STAFF REPORT
May 4, 2023
Site Plan Review for Parcel Id # 05-917-00-07-008.00

Application for a Site Plan Approval

Address: 14781 N. Fairview Dr.

NEW BUILDING FOR
FAIRVIEW NORTH SHOPPING CENTER
SMITHVILLE, MO

Colored
Elevations

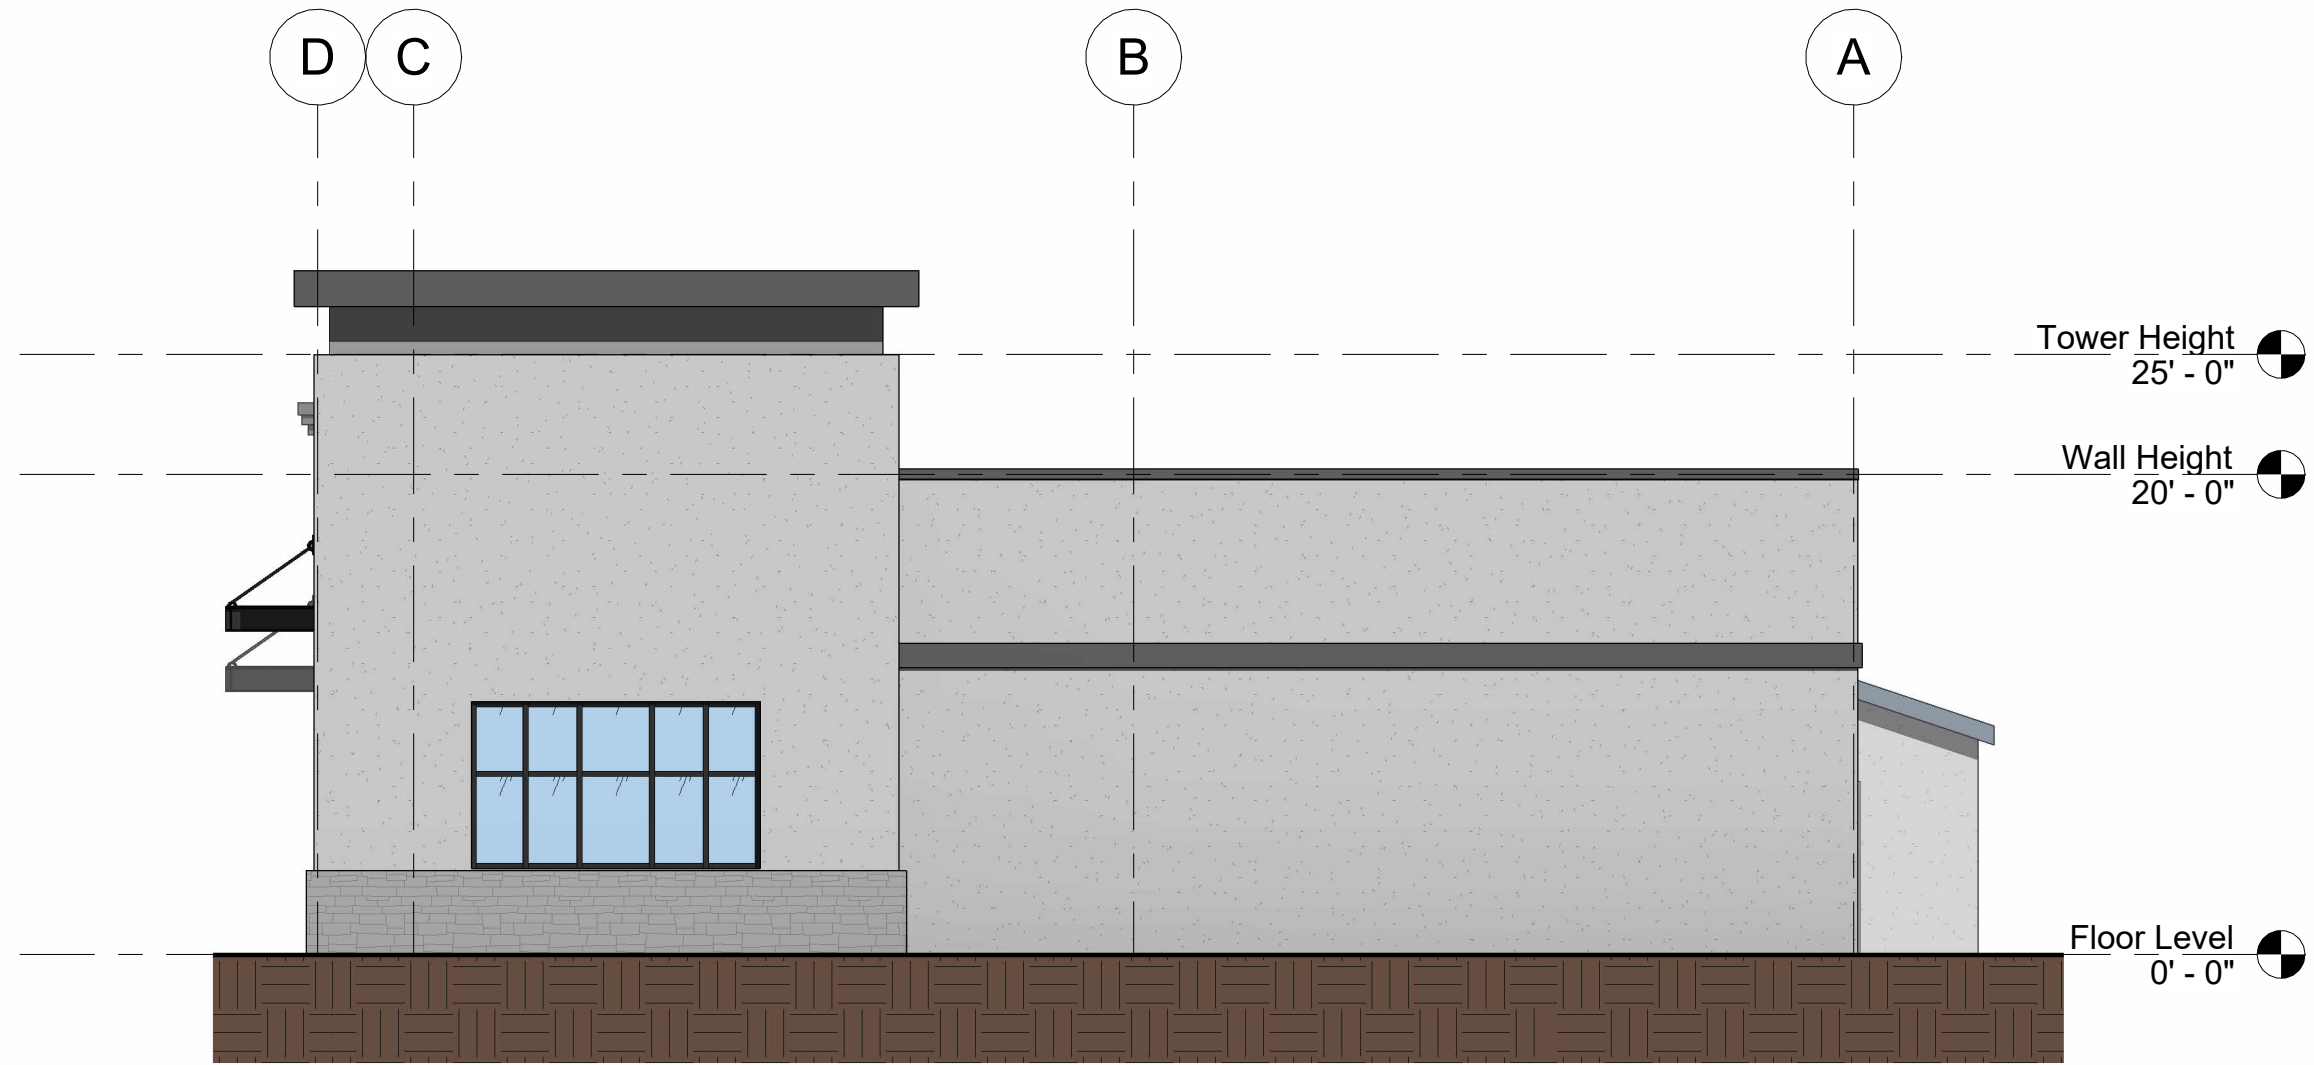
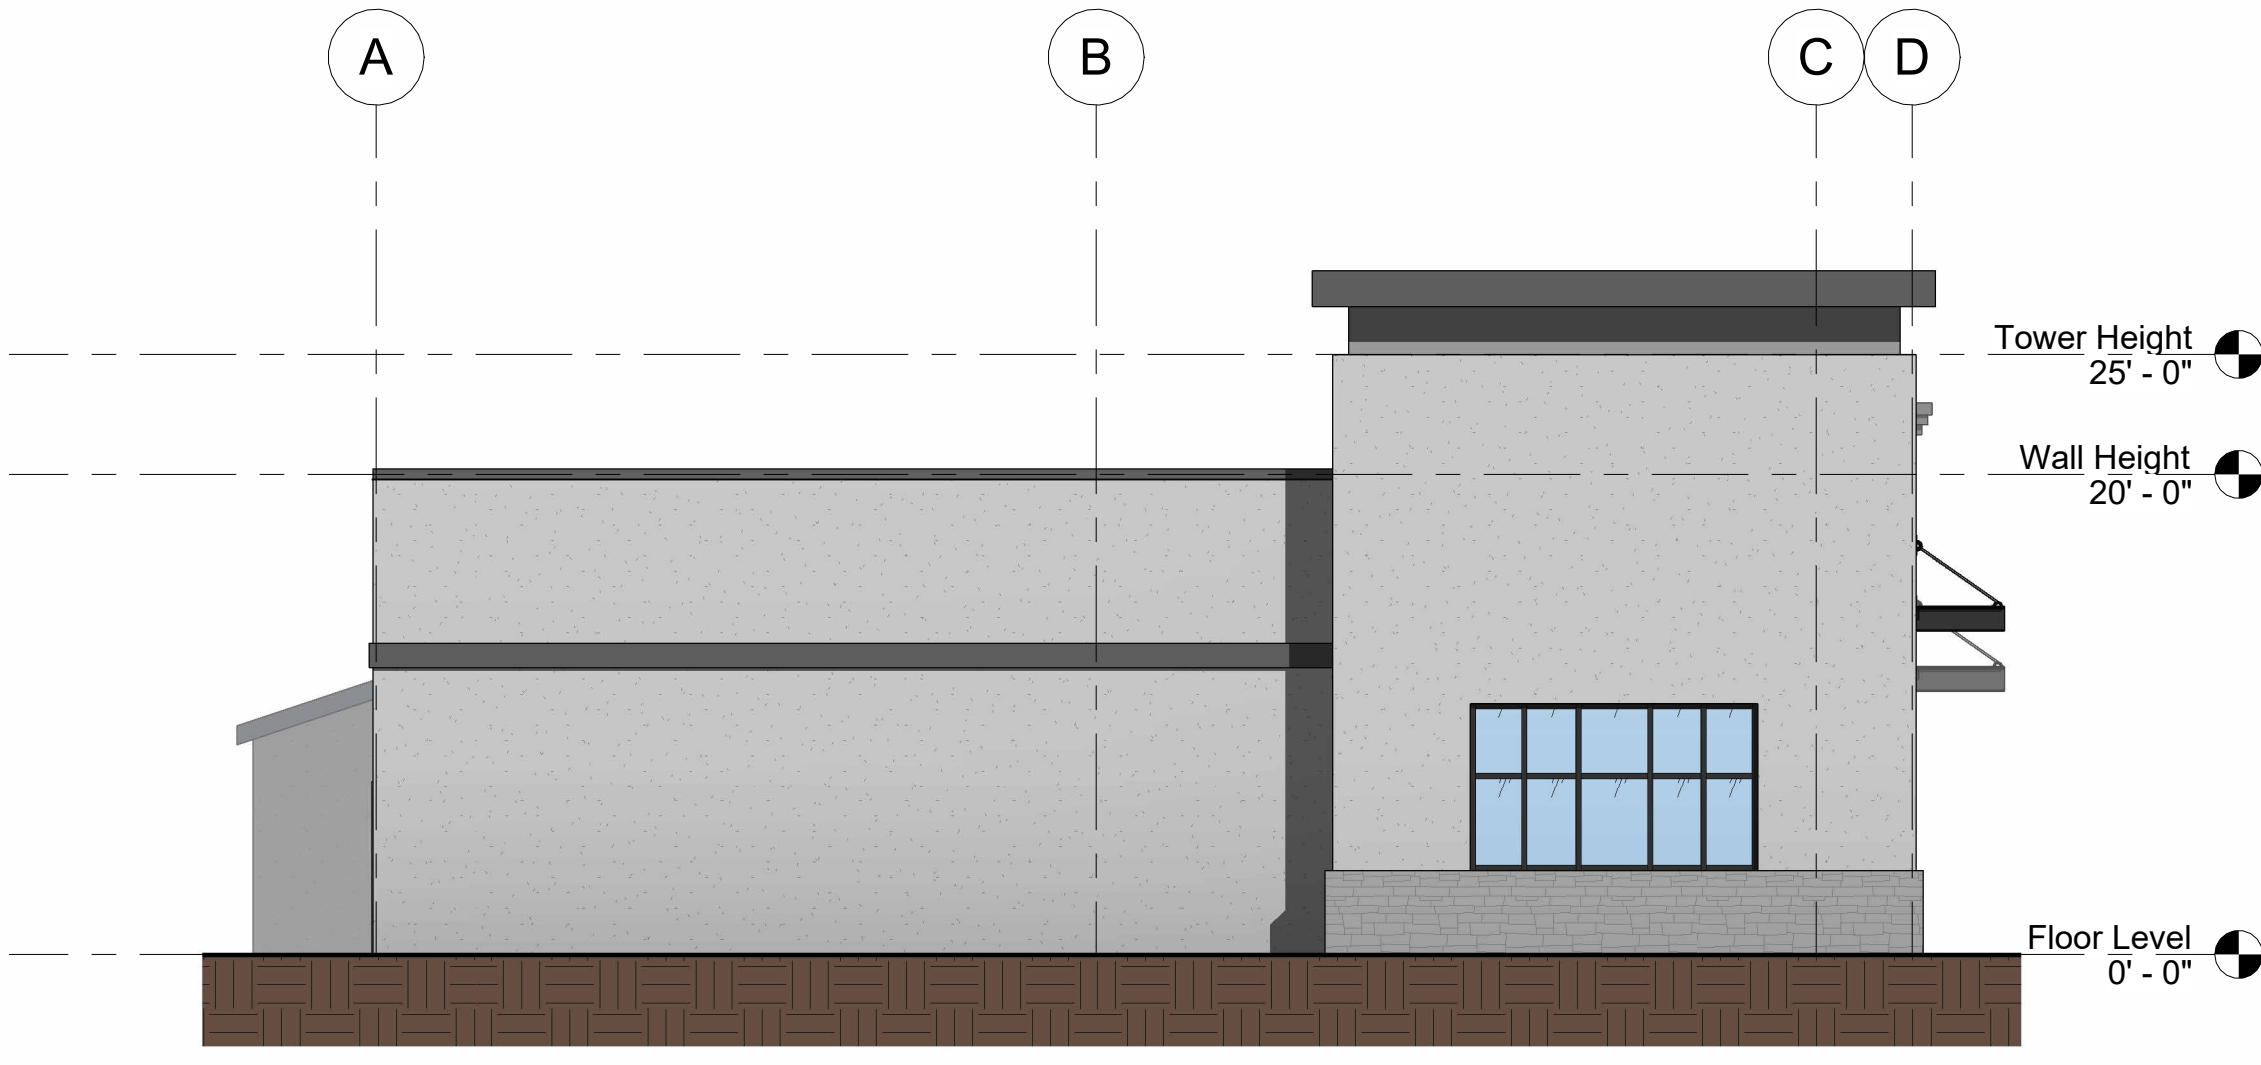
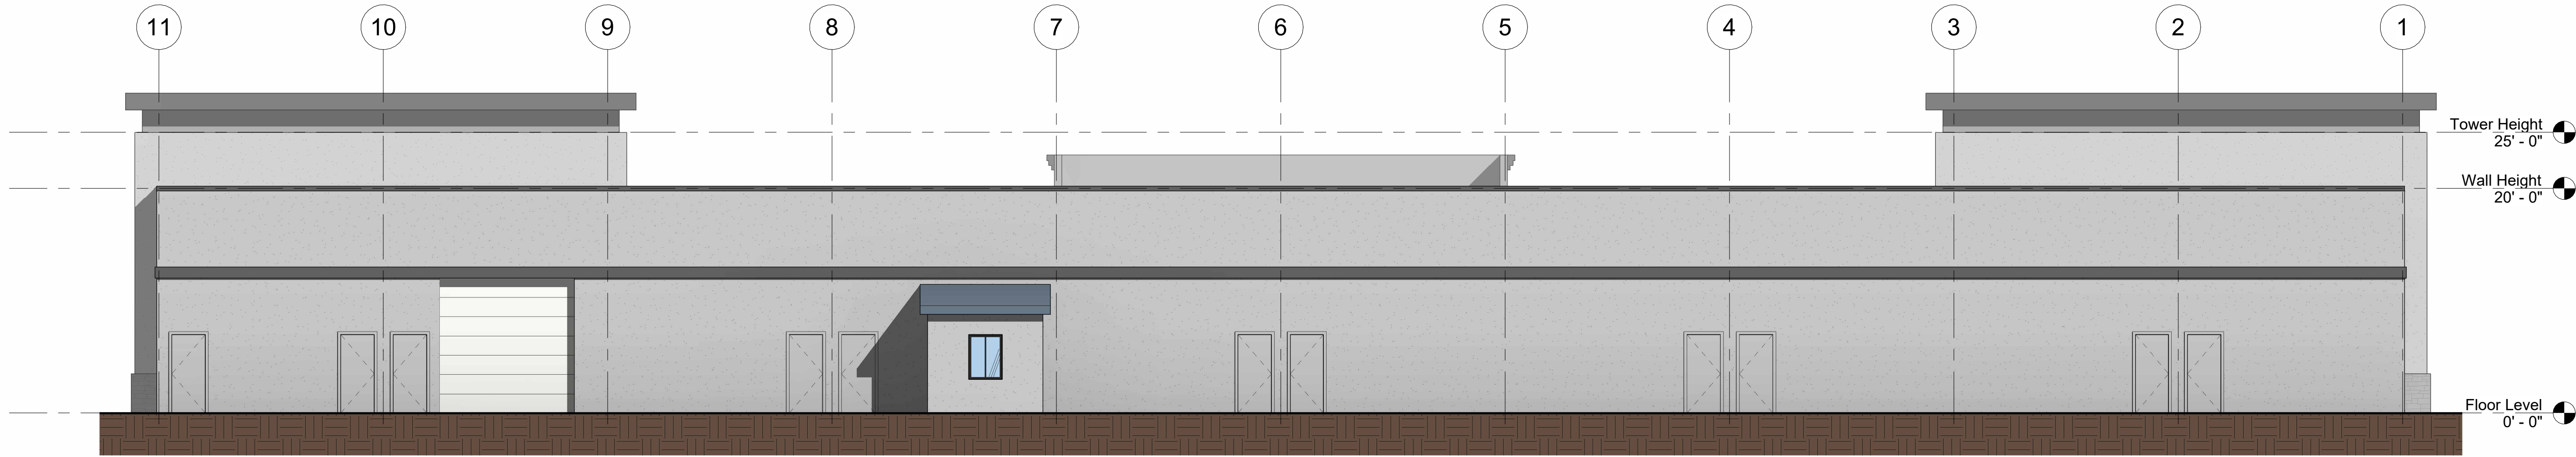
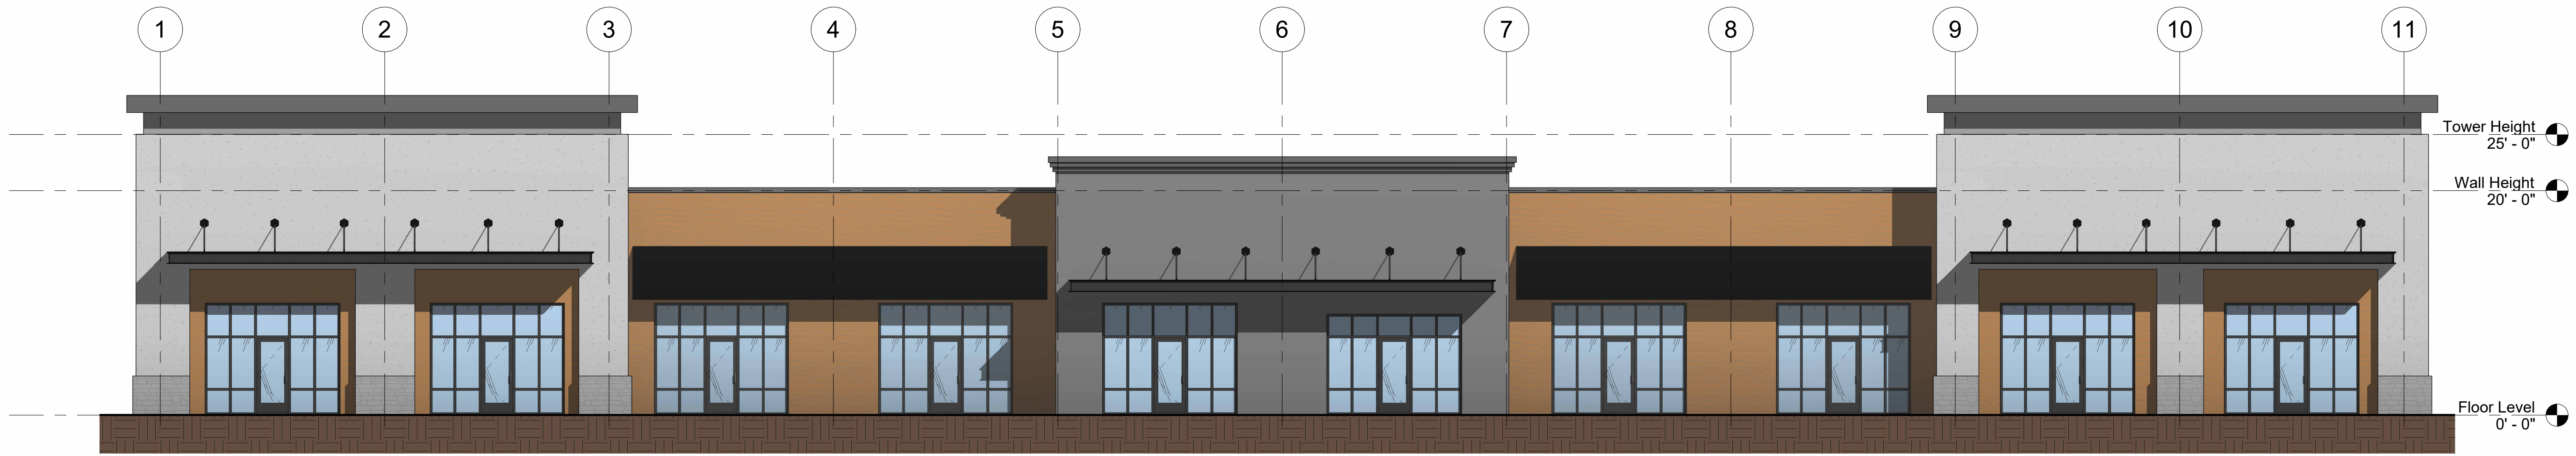
Staff recommends APPROVAL of the proposed Site Plan conditioned upon including the changes to the plans for the rear and partial sides to create defined top, middle and bottom sections in accordance with the existing portions of the sides that meet the standards.
